Interactive comment on “Impact of LUCC on Streamflow using the SWAT Model over the Wei River Basin on the Loess Plateau of China” by Hong Wang and Fubao Sun

Subject: Revise the manuscript (#hess-2016-332)

The Title: Impact of LUCC on Streamflow Based on the SWAT Model over the Wei River Basin on the Loess Plateau of China

Fig. 1. Fig. 1 The development of soil and water conservation measures in the main stream basin of Wei River over last 50 years.

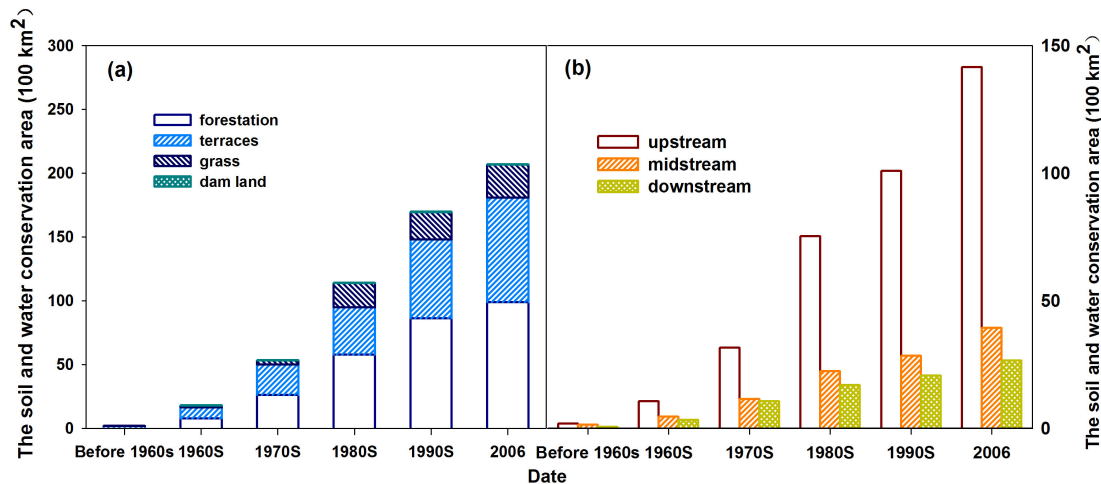
1: First of all, I am questioning the significance of the hydrological changes that actually occurred in the catchment over the studied period. Although figure 1 indicates that forested areas increased by about 65.104 hm² (unusual unit used on the Y axis), which is equivalent to 14% of the upper catchment area, figure 3 inconsistently shows that forested area increased by only 0.81% (line 137) over the same period (1980 to 2005). How to explain this difference? If we rely on figure 2 (which is likely the most reliable source), we can expect minor influence of forestation on the basin hydrology.

(34) Fig. 1: Areas under different treatments are expressed in 104 hm² (i.e. squared hectometers?). This is an atypical unit which is different from the unit used for the study area in the text (104 km²). All areas should be provided in same unit to allow easier comparison. It would be clearer to provide the percentage area so that we anticipate the possible effect of the land treatment on the catchment hydrology.

Thank you for pointing this out, which makes us think it through. In fact, these two datasets are from different sources. First of all the number in Fig. 1 is for 6.53% (instead of 14%) as shown in detailed explanation below, which is still higher than 0.81% as pointed by the referee. This is a classic issue in the national survey on soil and water conservation where they only take the revegetation implemented into account and ignore for example possible death of vegetation, which is important in the land use map. One more thing is that the national survey when counting the revegetation areas does not consider the vegetation coverage, which is in fact important in any hydrological modelling including the SWAT modelling. We agree with the referee on that point. With that caution, however, Figure 1 is just for a reference on the development of the soil and water conservation project in China. The data we are relying on are the land use maps. Detailed explanation below:

(1) There are some detailed descriptions about Fig.1. The same legends for Fig.1 (a) and (b) brought some confusion, so we revised the legends of Fig. 1. Figure 1 is the developing process of the soil and water conservation measures in the main stream basin of Wei River, including the upper and middle reaches (4.68×10^4 km²) and the

downstream of the main stream (1.65×10^4 km²). Figure 1 involves about 6.33×10^4 km². Figure 1 (a) is the area developing of forestation, terraces, grass and dam land separately. The area of forestation was about 57.43×10^4 hm² during 1980s and it increased to 98.75×10^4 km² in 2006, which equivalent to 6.53% of the main stream basin of Wei River. And Fig. 1 (b) is the sum area of the forestation, terraces, grass and dam land in upstream, midstream and downstream. And the sum area increased by about 66.15×10^4 hm² in upstream.

(2) Figure 1 is the statistical data of government based on natural forest before and artificial planting area, which involves all planting of forestation without considering canopy density, surviving or deforestation and so on. The forest of the LUCC data refers to the natural forest and plantation, which canopy density is larger than 30% (Table 3: note "a").

(3) The forest data of Fig. 1 also includes planting land used as agro-fruit, agro-mulberry, agroforestry and replanting land for trees. While land used for agro-fruit, agro-mulberry, agroforestry is classed as Agricultural land (Table 3: note "a") in LUCC.

(4) There are also some screening conditions for land use types dividing in SWAT model. For hydrological response unit (HRU) analyst, the Dominant Land Use method was used for HRU definition. So the dominant unique combination of land use in the subbasin is used to simulate the HRU. Figure 1 shows the area of grass is smaller than forest's, while it is opposite in LUCC and SWAT model attributed to canopy density and the Dominant method.

Thank you for your suggestion. Figure 1 is revised as suggestion.

Fig. 4. Fig. 1.1 The monthly time-series graphs of calculated vs. observed values during calibration period and verification period for hydrological stations

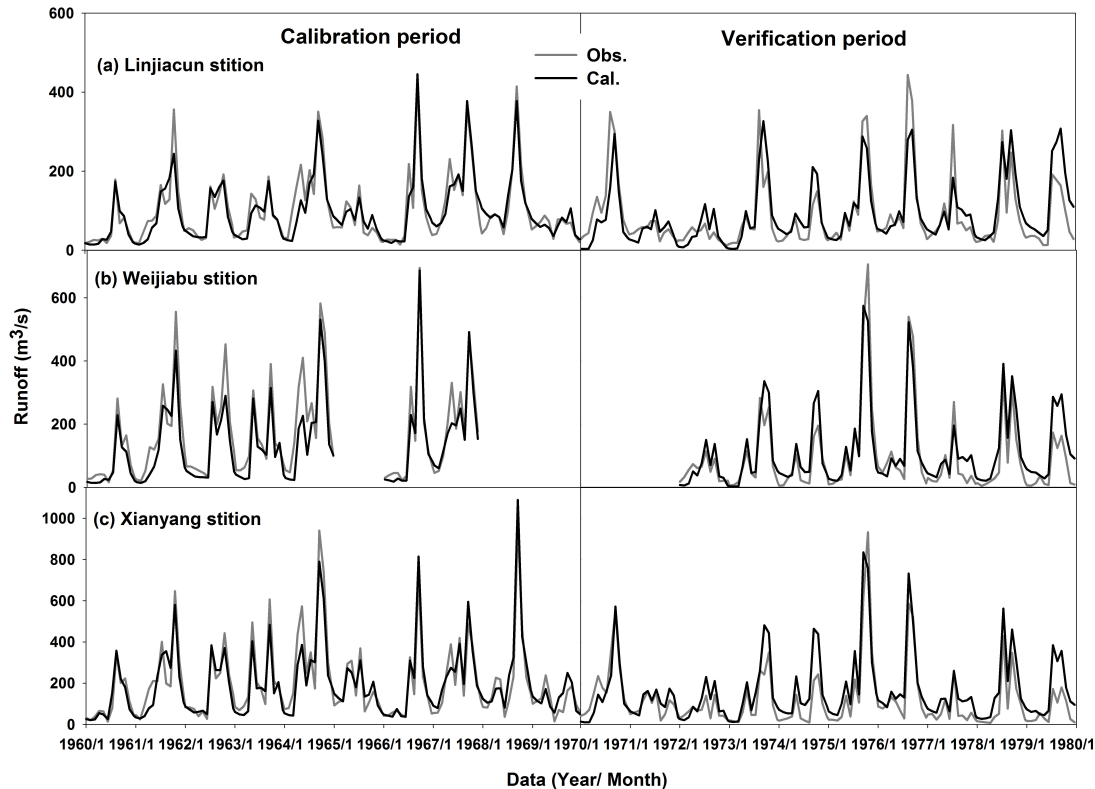
(27) Lines 257, 258: unlike what is written, the trend is not obvious in fig. 6. It would be clearer to redraw the figure at the monthly and annual time steps to visualize possible trends over years.

Thank you for your suggestion. The monthly time-series graph of calculated vs. observed values during calibration period and verification period for hydrological stations is as follows.

Fig. 5. Fig. 7 The time-series graphs of calculated vs. observed values during calibration period and verification period for hydrological stations.

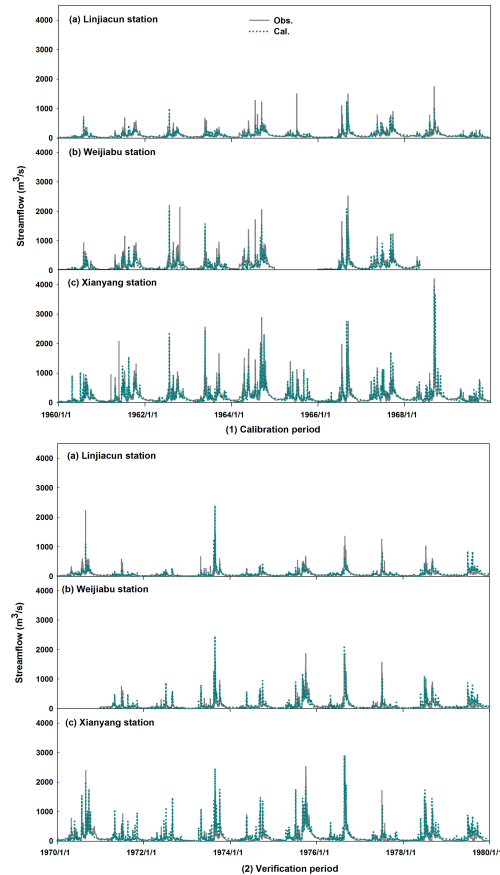
(36) Fig. 6. The scale on the X axis is too big: we cannot see the details in the daily flow variations and in the matching between observed and simulated flow. The figure should be bigger or all panels (calibration and verification should be put in the same column to allow larger size.

Thank you for your suggestion. It is more clearly indeed as suggestion (Fig. 7).

Fig. 6. Fig. 11 The corresponding proportional change rate of streamflow at Linjiacun, Weijiabu and Xianyang station for annual average and annual average in non-flood season.

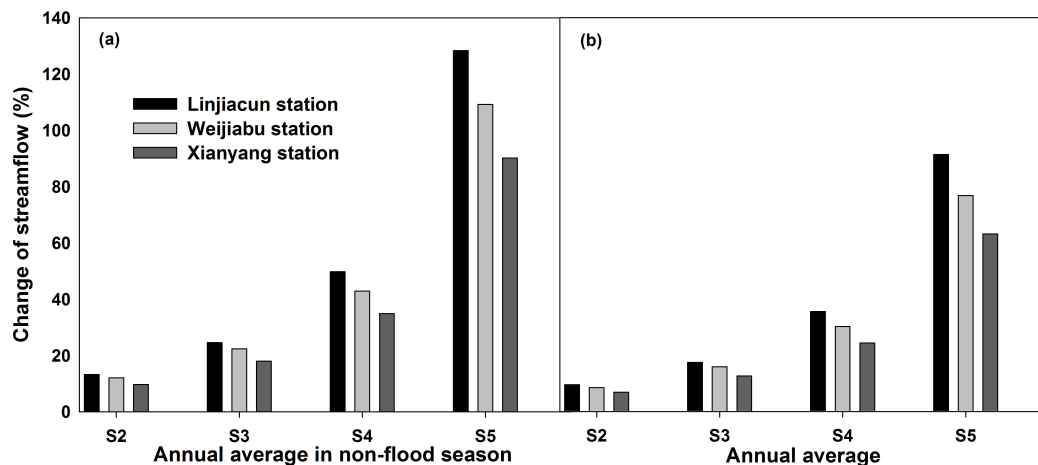
(37) Fig. 9: What is the meaning of “corresponding proportional change rate”?

Thank you for your suggestion. It is the change rate of streamflow at the Linjiacun, Weijiabu and Xianyang stations correspondingly. We have revised the figure (Fig.11).
